A. REPORT TO THE HEARING EXAMINER

Project Name: Cedar Ridge Church Expansion

File Number: LUA16-000128, ECF, CU-H, V-A

Project Summary: The applicant is requesting Hearing Examiner Conditional Use Permit, Environmental (SEPA) Review, and a Height Variance for a proposed addition to the Cedar Ridge Church. The proposed addition would include a 3,237 square foot basement, 6,210 square foot main floor, and 2,733 square foot balcony for a total area of 12,180 square feet. The proposal would increase the existing total seating capacity within the church to 301. The existing original 2,540 square foot church building would remain and would be converted to classroom and fellowship hall space. The project site totals 168,630 square feet (3.87 acres) and is zoned Residential-8 (R-8). The height of the proposed addition would result in a maximum height of 40'-1". The proposed project includes the addition of 20 parking spaces, resulting in a total of 60 parking spaces on site. Access to the site would remain off of SE 164th Street via one curb cut. A sensitive slope (grade between 25 and 40 percent) and two Category 3 wetlands have been identified on the project site (Wetlands A and B). W

2 EAST ELEVATION
1/8" = 1'-0"

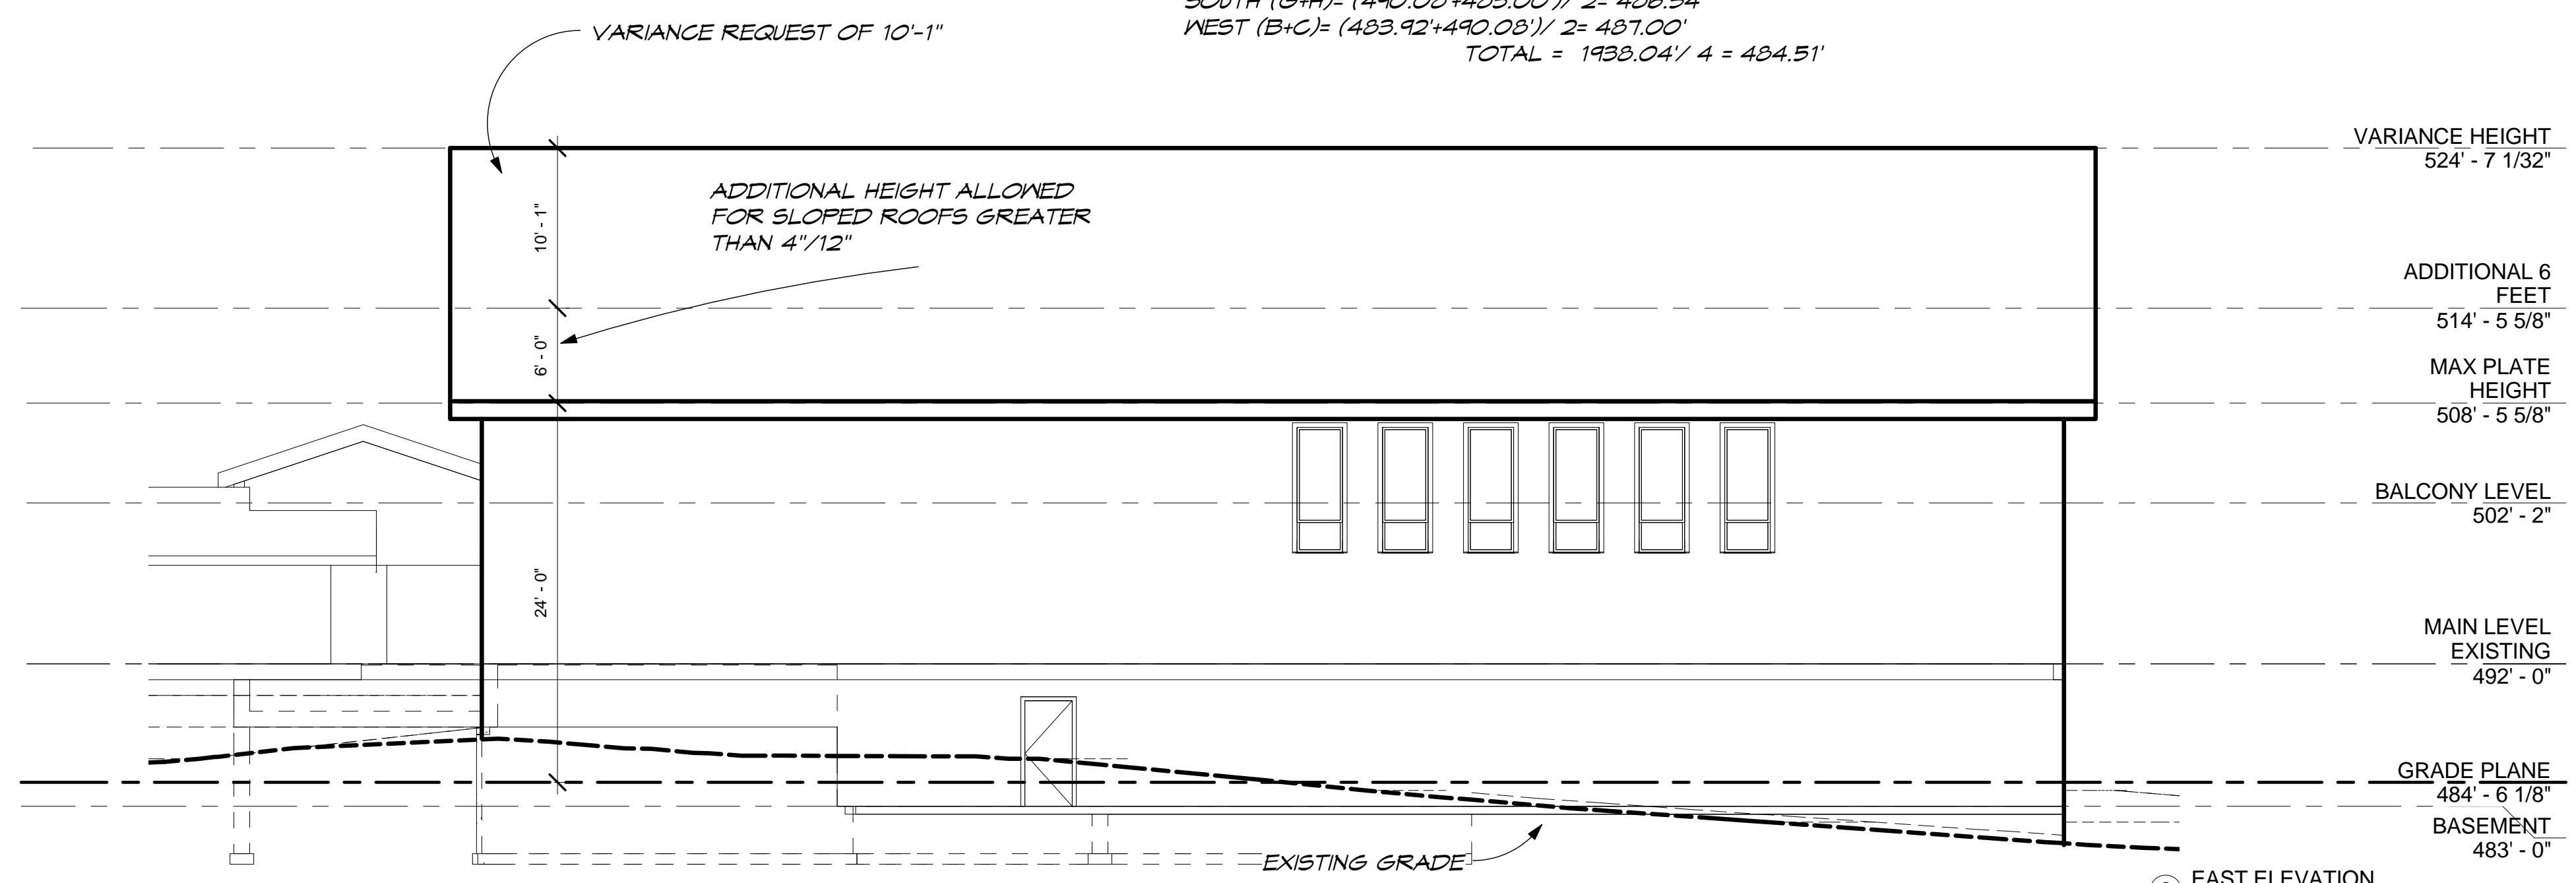
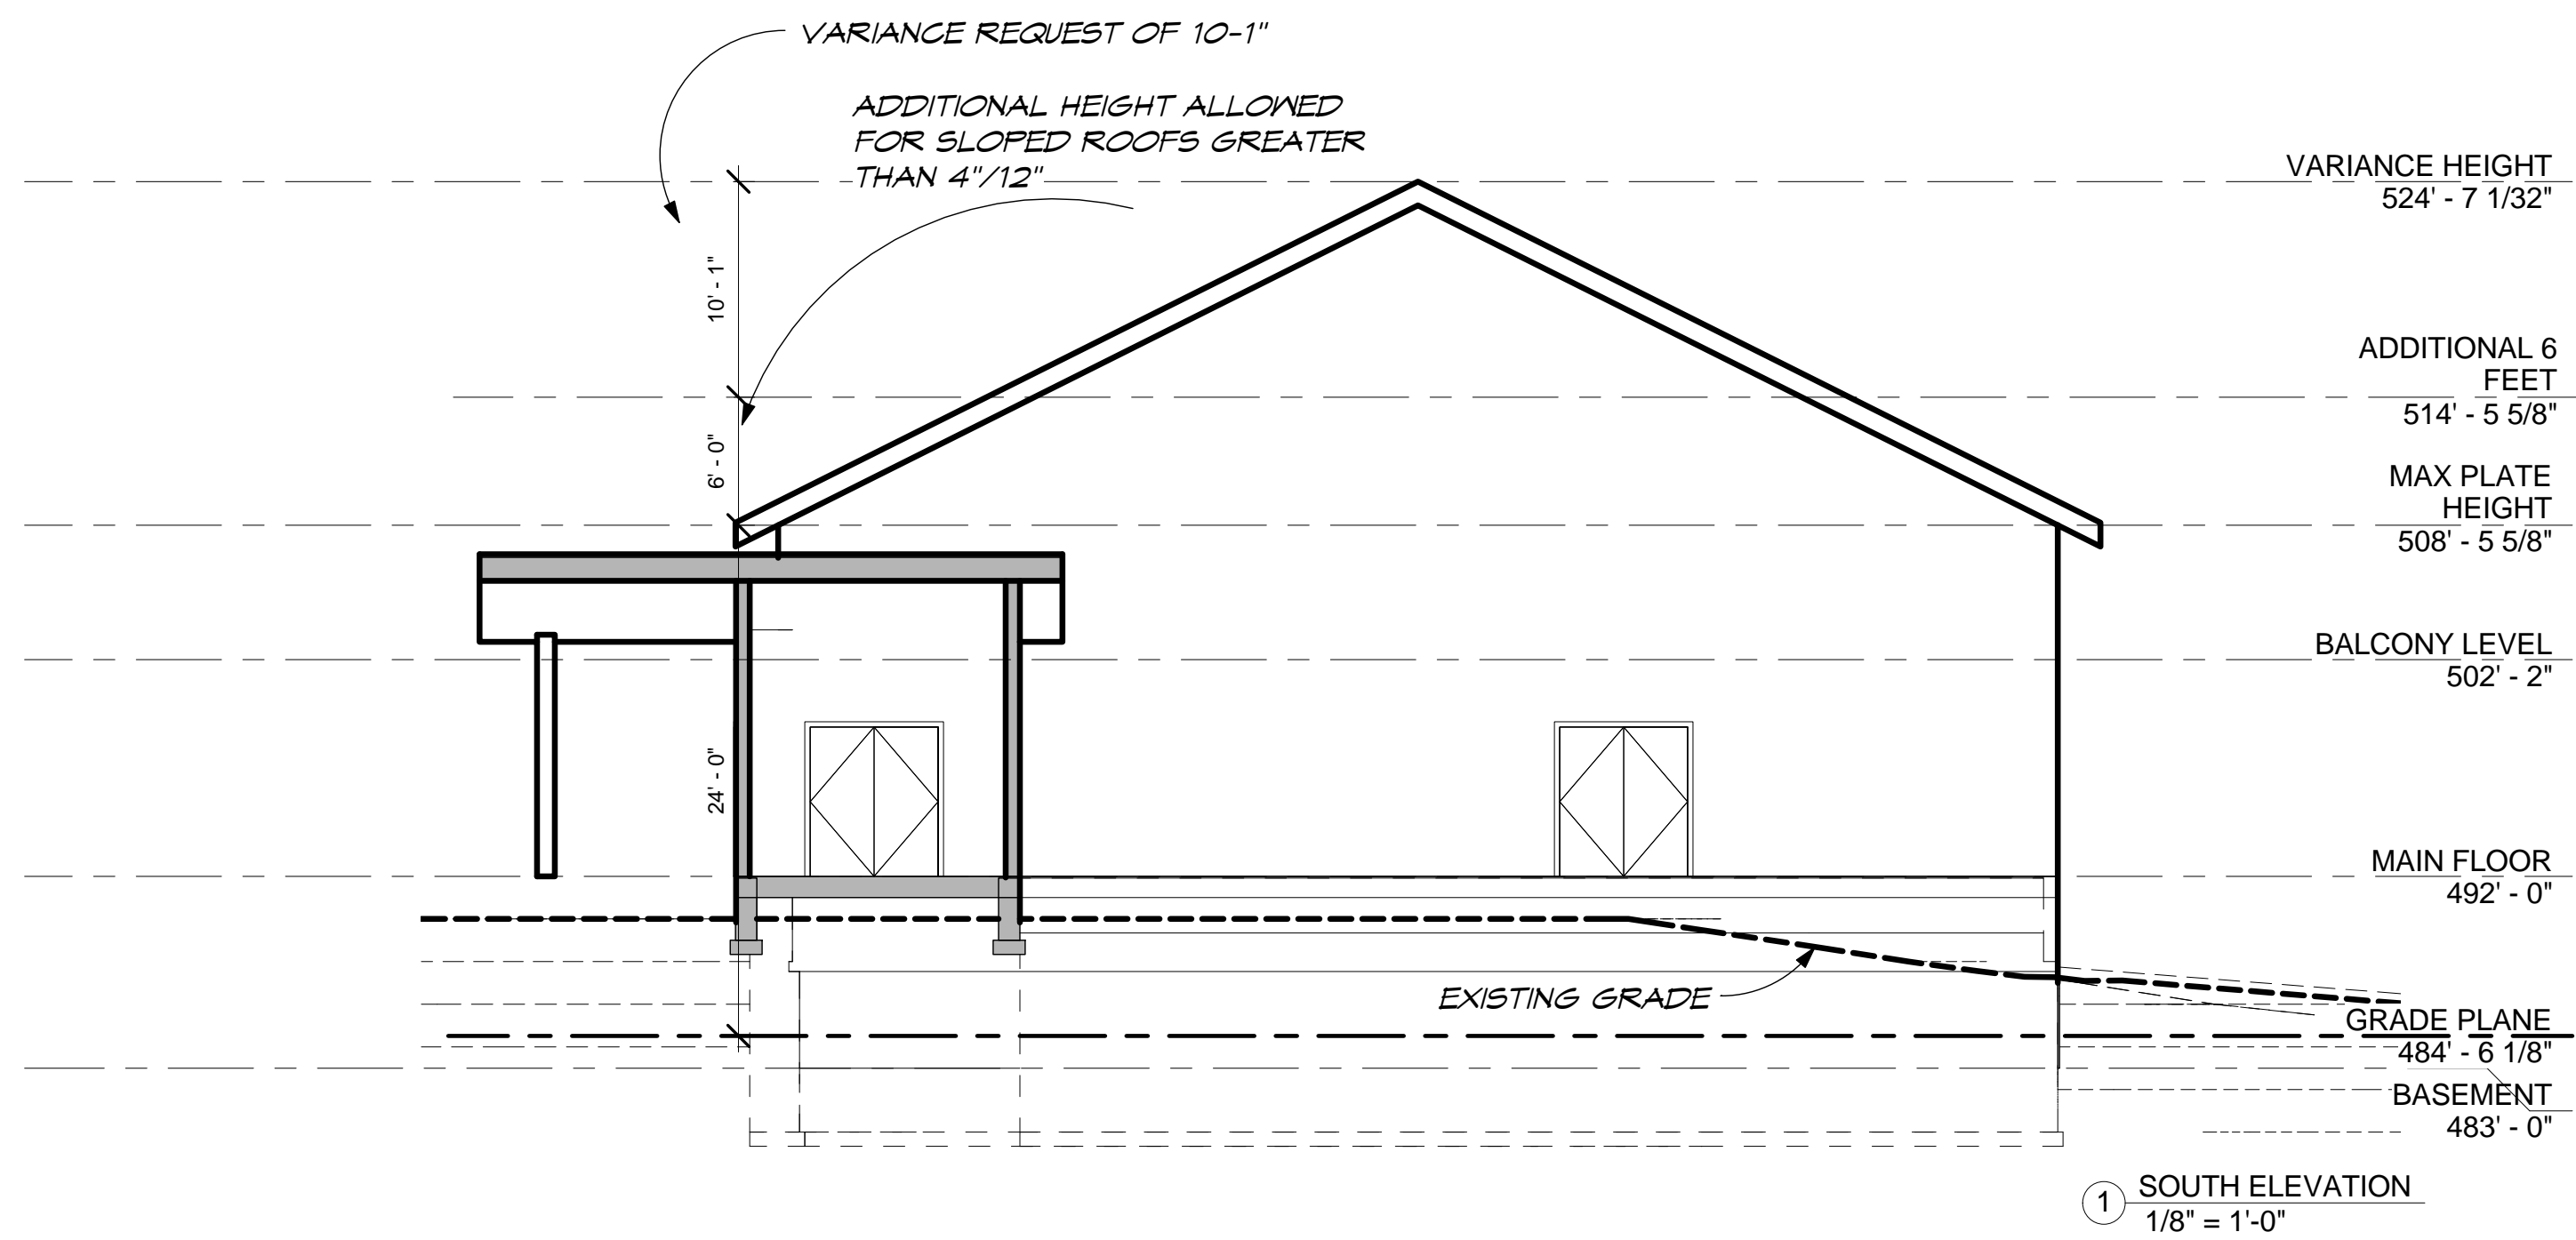
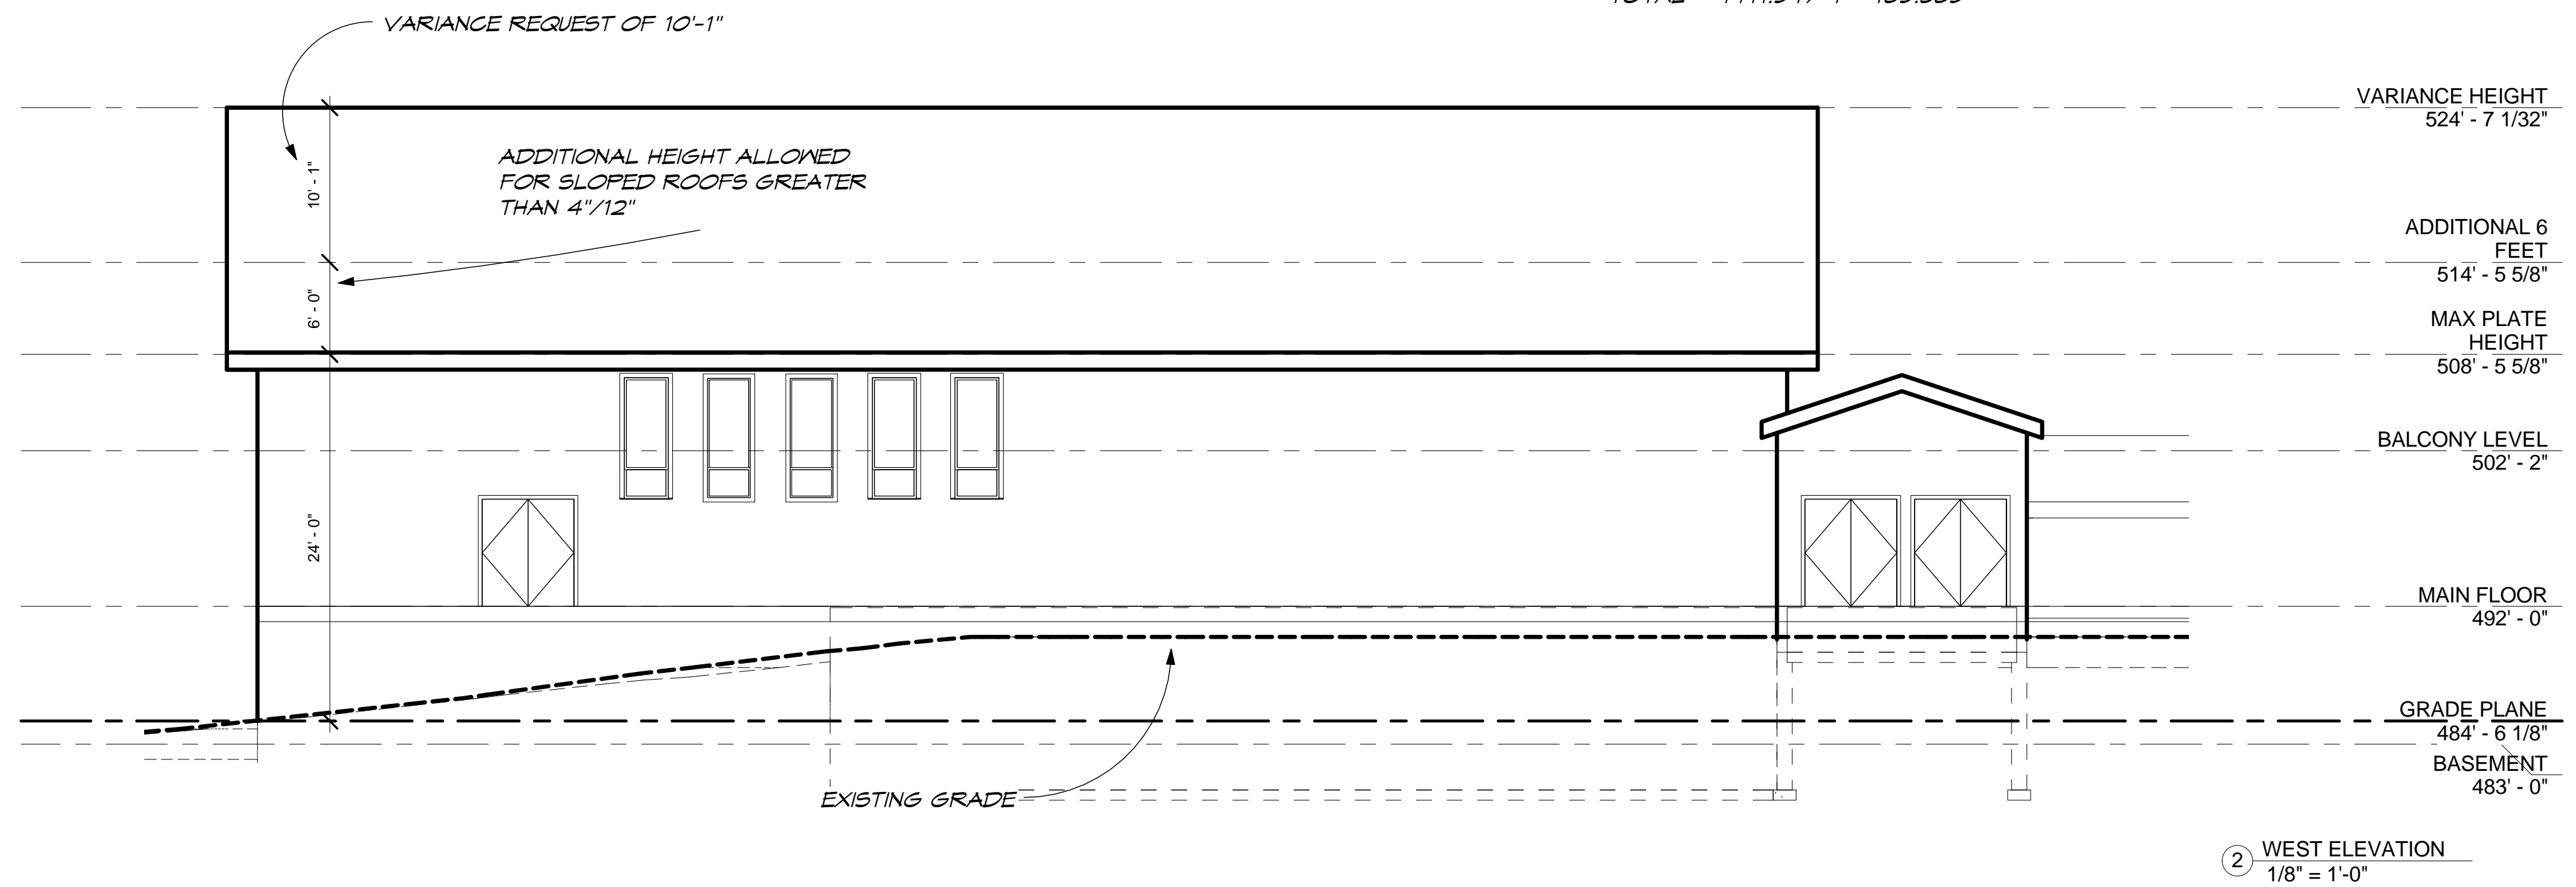
19. **Variance Analysis:** The applicant is requesting a variance to the overall maximum permitted height of 30 feet in the R-8 zone for the construction of the proposed church addition. The proposed addition would have a maximum height of 40 feet 1 inch. The proposal is compliant with the following variance criteria, pursuant to RMC 4-9-250. Therefore, staff recommends approval of the requested Variance.

✓	<p>c. That approval shall not constitute a grant of special privilege inconsistent with the limitation upon uses of other properties in the vicinity and zone in which the subject property is situated.</p> <p><i>Staff Comment: The granting of this variance would not be considered a special privilege in consistent with other church uses in residential zoning designations. The applicant provided examples of other churches and an elementary school that exceed the maximum 30-foot height limit (Exhibit 19).</i></p>
✓	<p>d. That the approval is a minimum variance that will accomplish the desired purpose.</p> <p><i>Staff Comment: The approval of this variance is the minimum necessary to allow the applicant to construct a two story addition to their church building and provide a 6:12 roof pitch. As previously stated above, the addition would comply with the R-8 zoning requirements for the maximum number of stories, as well as the maximum 24-foot wall plate height. However, due to the size of the proposed addition, the overall maximum 30-foot height limit would be exceeded by 10 feet 1 inch.</i></p>
